BPC Central Small Diameter Package 4C
Solicitation Number: CO-00487
Job No.: 20-4523

ADDENDUM 1
November 3, 2021

SANITARY SEWER LINE REHABILITATION PLAN
 SITE 316.C FRAN FRAN ST
 S CALAVERAS TO FRIO CITY RD

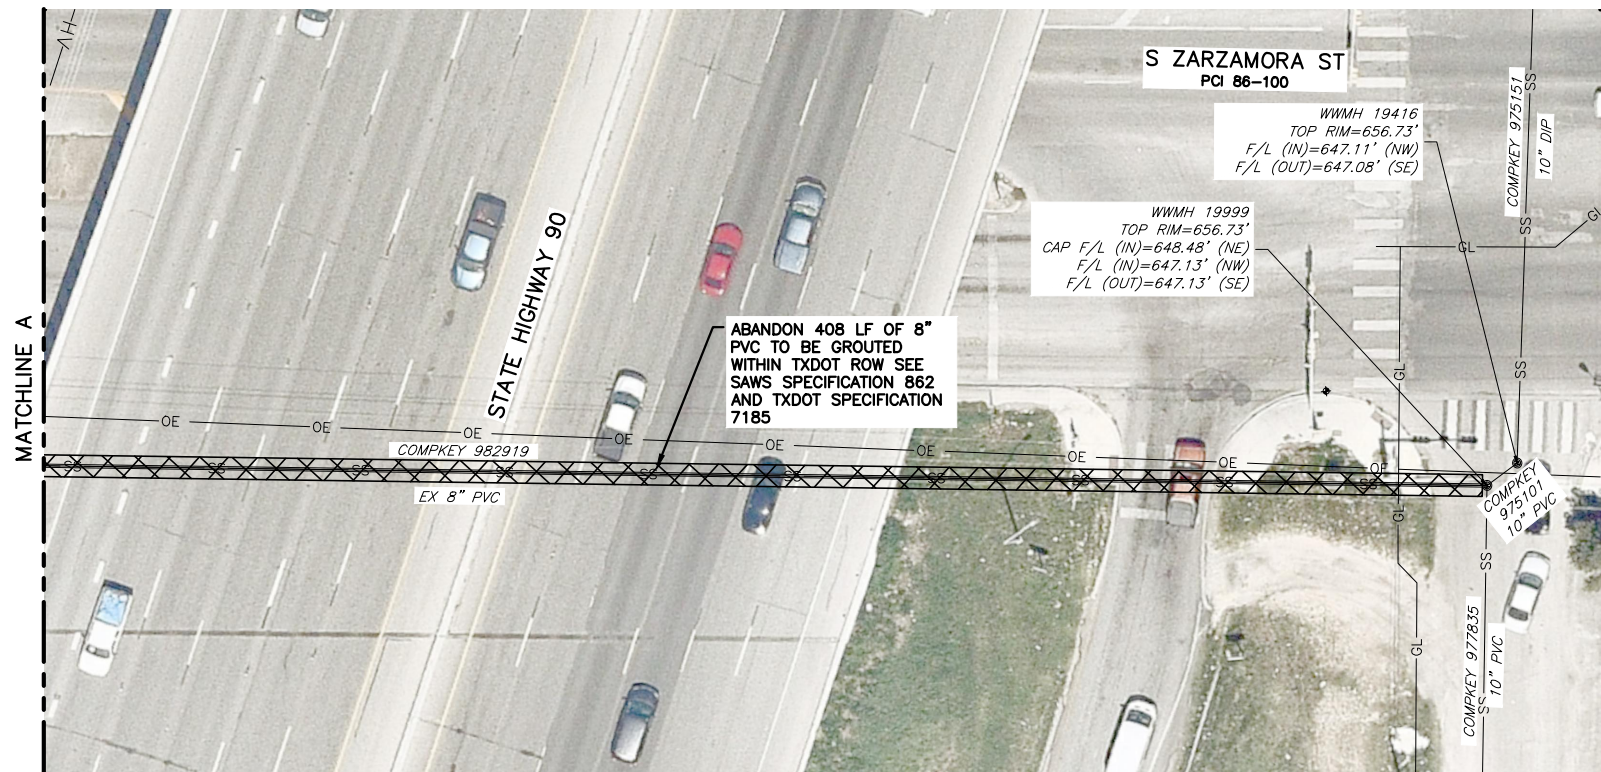
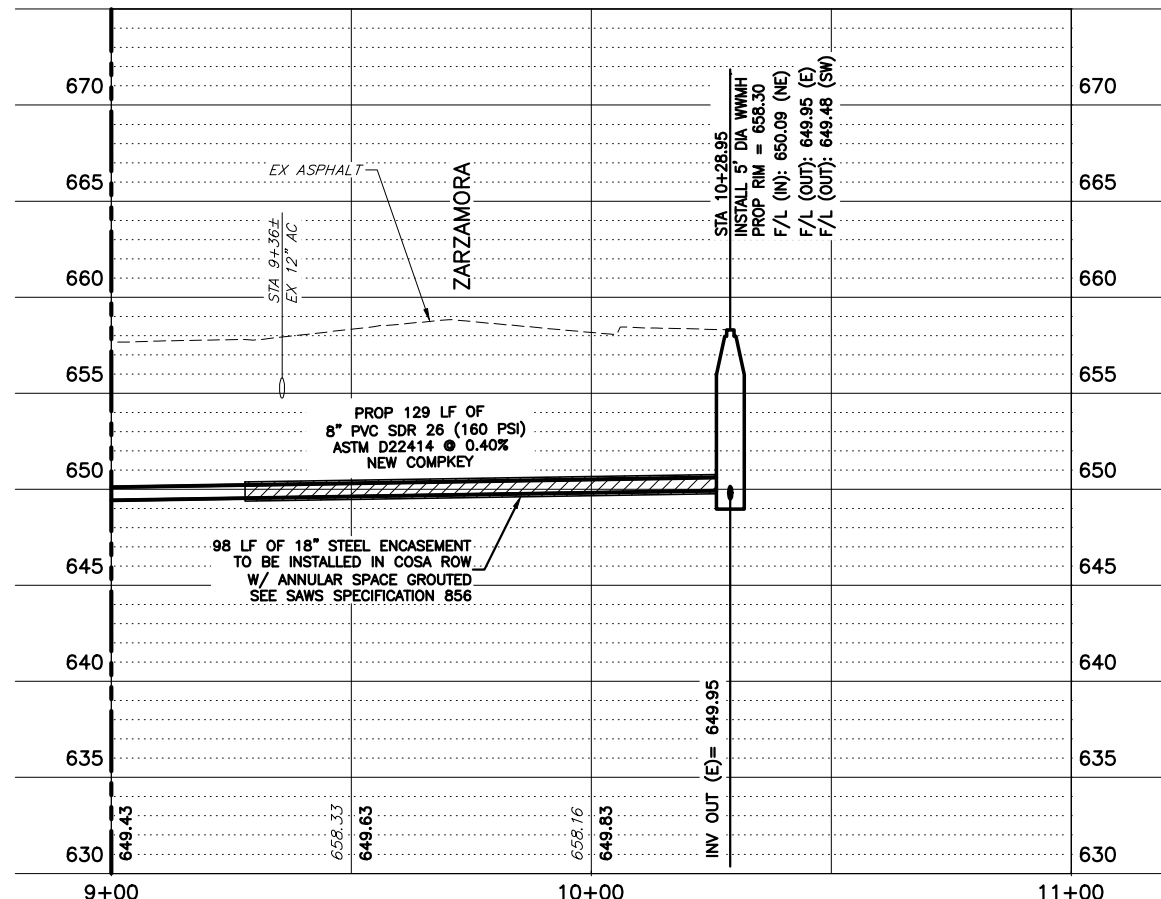
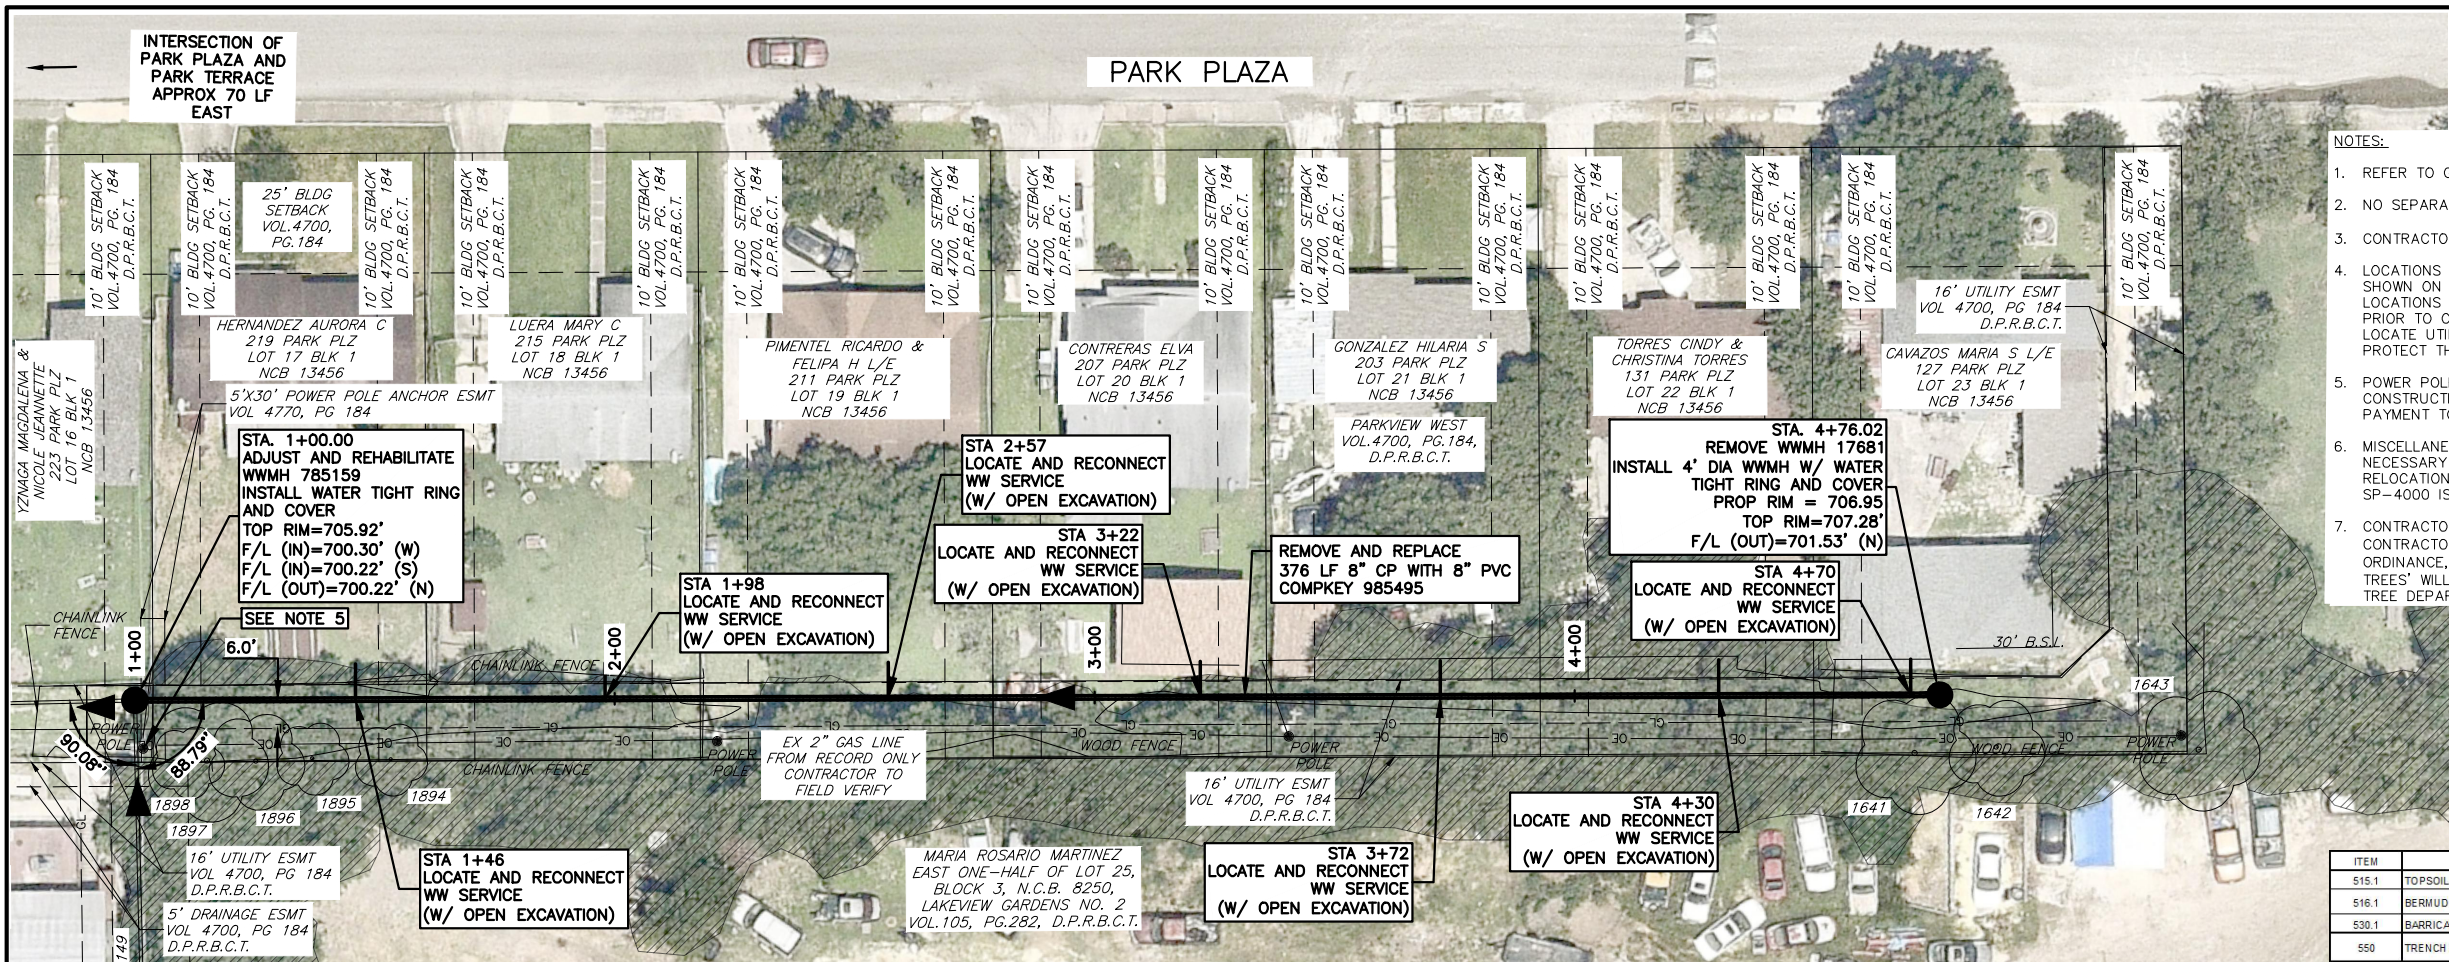
REMOVE Sheet C-316.C in its entirety and REPLACE with the attached version. The following items were updated:

- a. In the sheet's quantity table, revise Item "857" to Item "856.6".

BPC CENTRAL SMALL DIAMETER PACKAGE 4C
SAWS JOB NO 20-4523
SANITARY SEWER LINE REHABILITATION PLAN
SITE 324 PARK PLAZA (ALLEY)
PARK TERRACE TO W COMMERCE ST

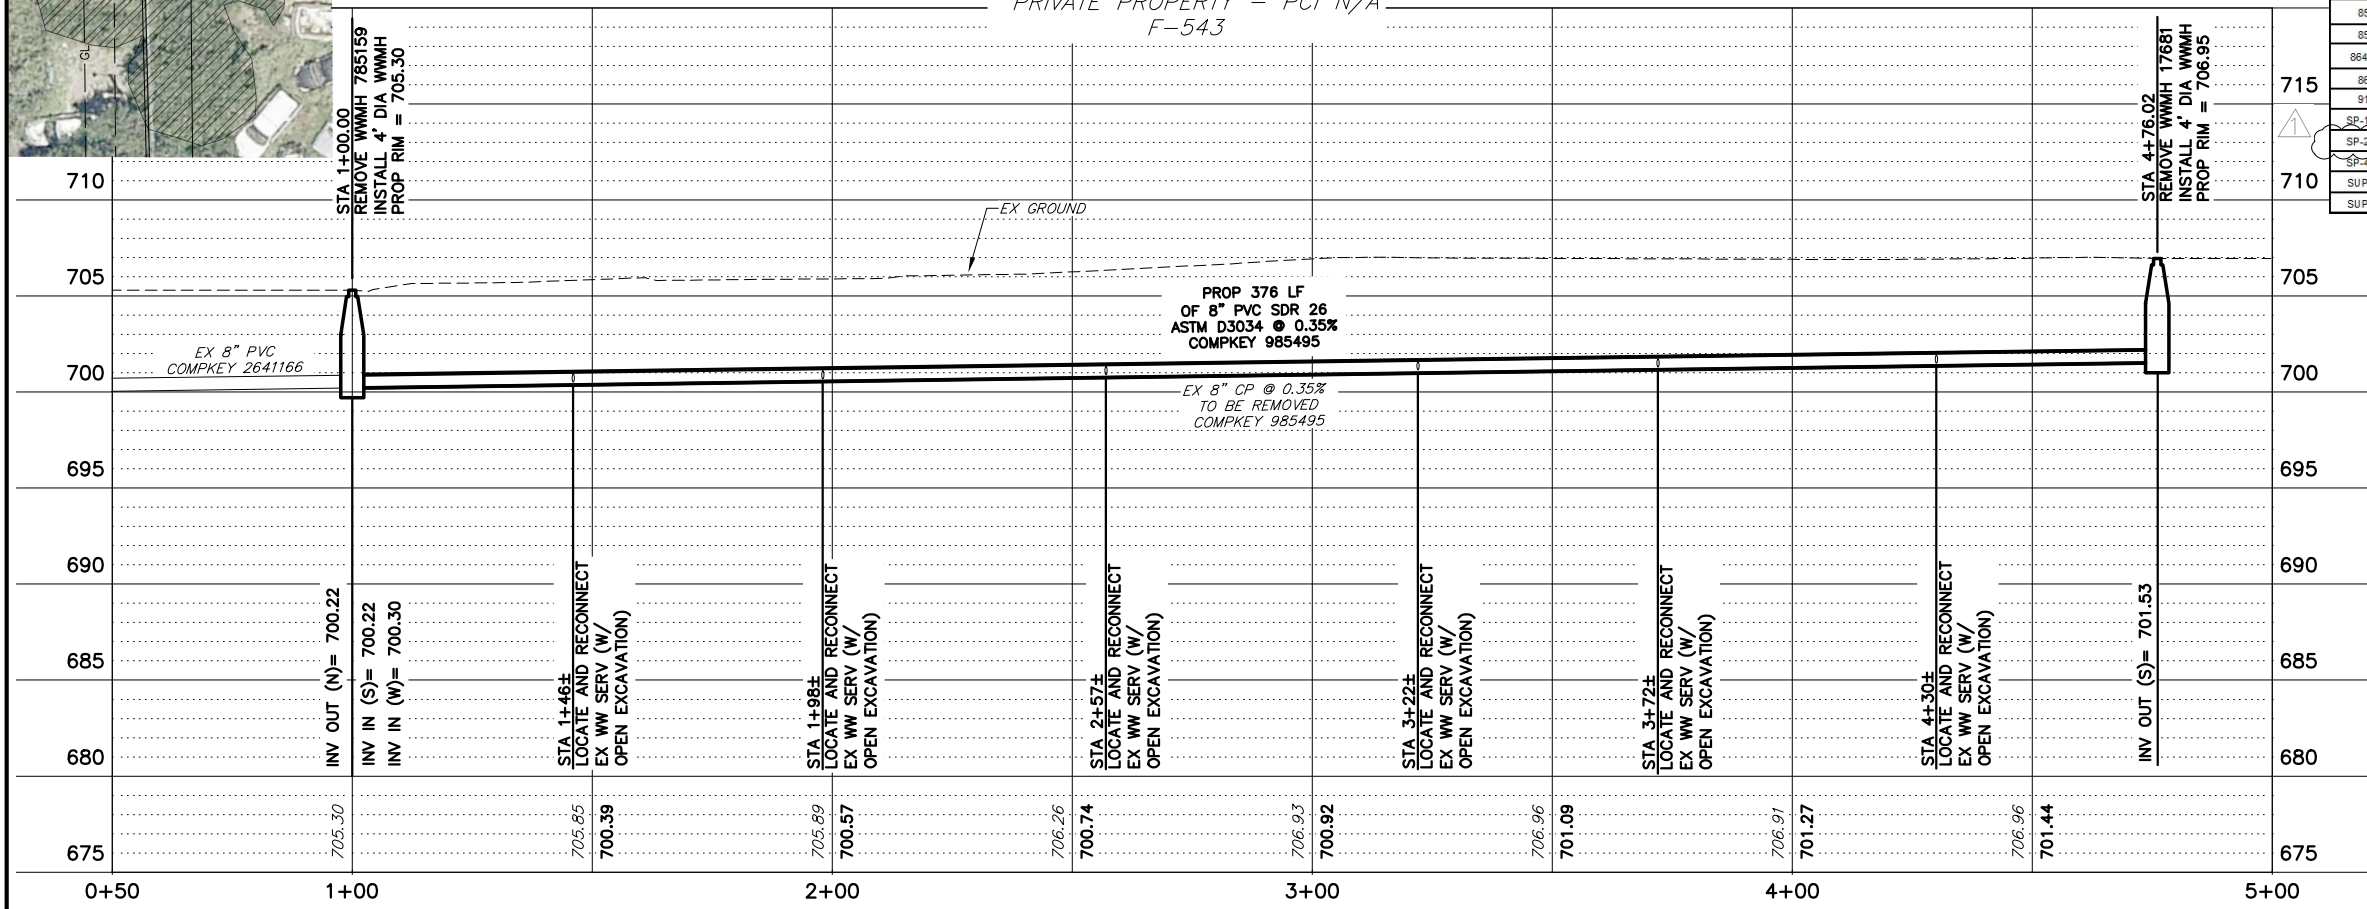
REMOVE Sheet C-324 in its entirety and REPLACE with the attached version. The following items were updated:

- a. In the sheet's quantity table, REMOVE Item Nos. 507.2 "Chain Link Wire Fence (6' High) (COSA Spec)" and 507.6 "Wooden Fence (6' High) (COSA Spec)", and REPLACE with Item No. SS-2010 "Removal and Replacement of Fencing", Qty "280 LF".
